FAT Test Protocol

40FT BESS Container 2

(Factory Acceptance Test)

Document number
23A2007_240706_FAT_40FT_BESS_Container_2_EN_v2.0

4.2 Container Visual Inspection (Exterior)

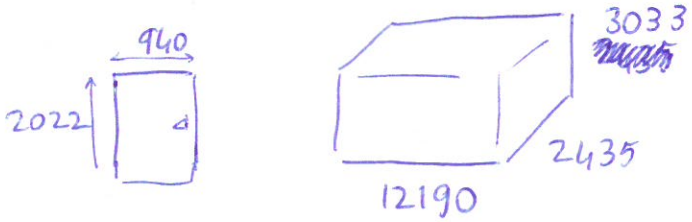
Remarks and description in case of defects:
BESS 2 – FRQ-534060000 1 Earthing of cooling niche doors + spikes and sharp edges on grid + cable tray to be fixed
